SHACKERSTONE ROAD

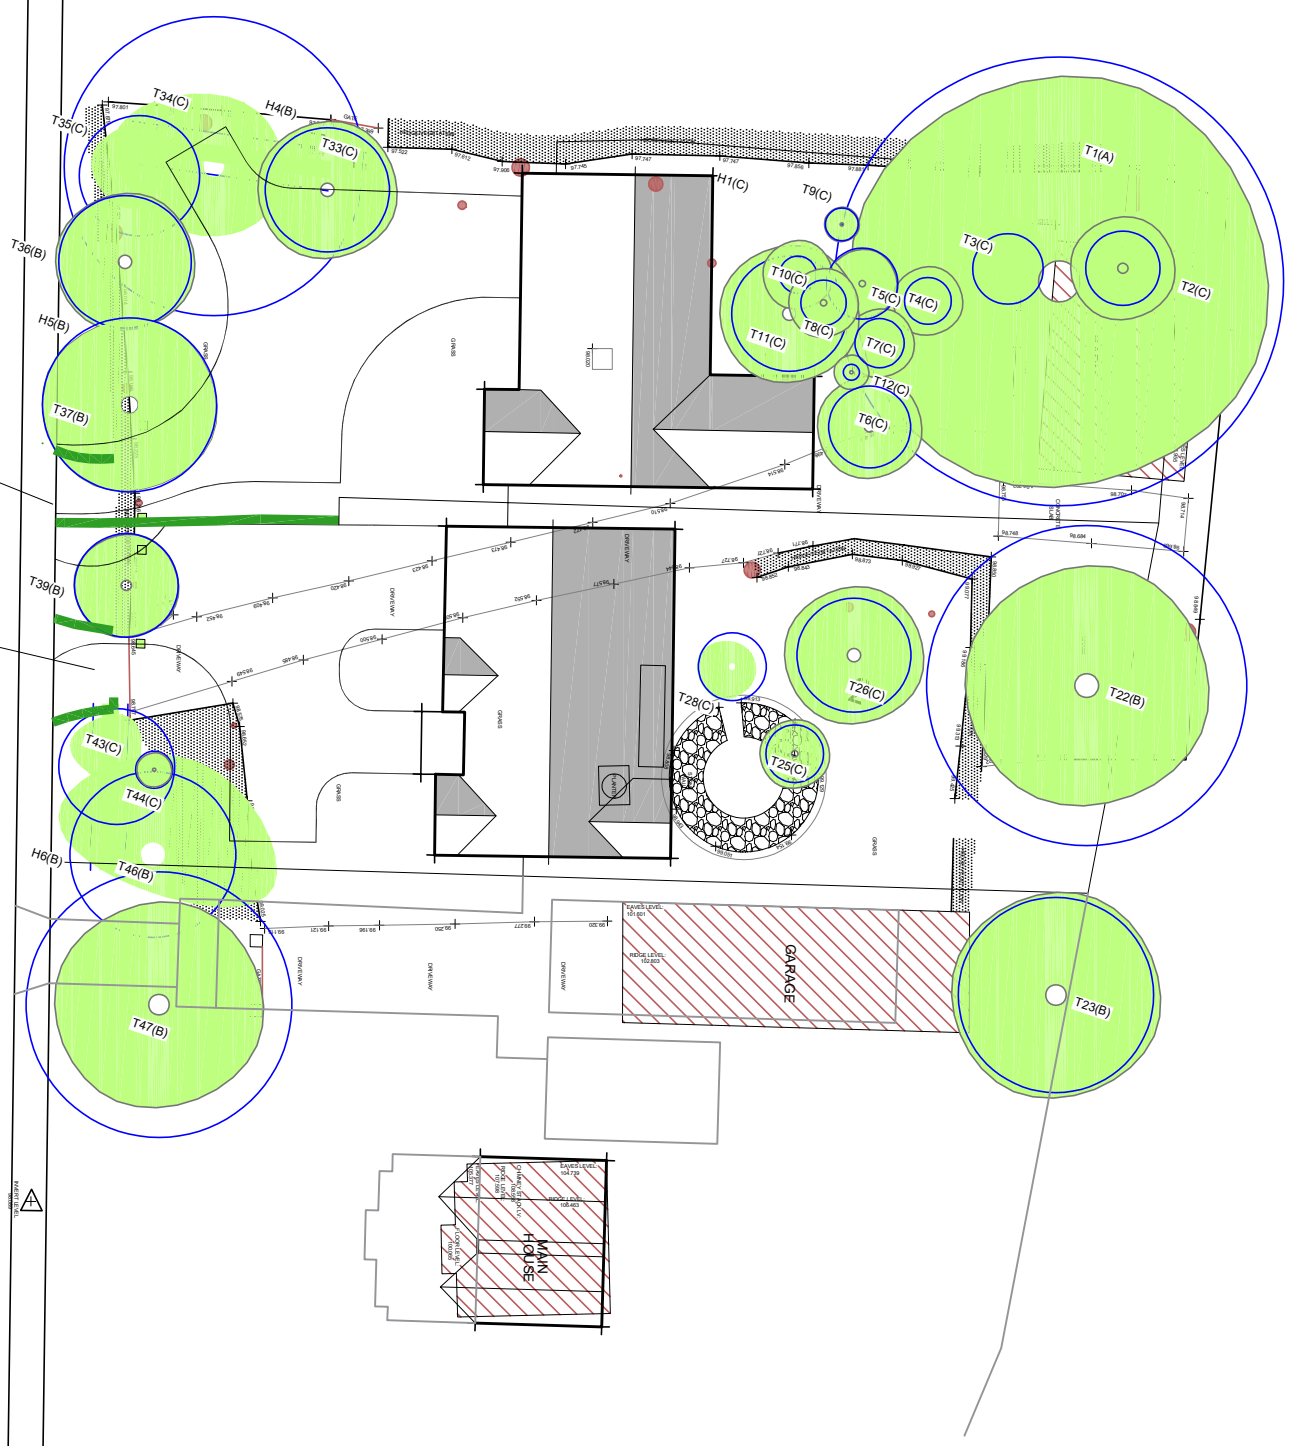
- Revisions**
- B - Additional hedge planting shown & notes updated. 07.11.23
 - C - Access width reduced, hedges updated, notes clarified and gates removed. 10.11.23
 - D - Minor landscape changes. 13.11.23
 - E - North point & scale added plus hedge crossing highway footpath removed.
 - F - Driveways amended to match all drawings. 22.12.23

— Additional new beech hedge planting shown. Circa 35m, which will include 4 no. 5m returns from the back of the footpath to comply with LCC highway requirements.

3.25m of hedge removed to provide access to property via driveway. **NO TREE WILL BE REMOVED** to provide the access.

Existing access modified to serve plot 2. Width to be reduced from 6m to 3.25m. The 2.75m width reduction will be provided via new beech hedge planting either side of access.
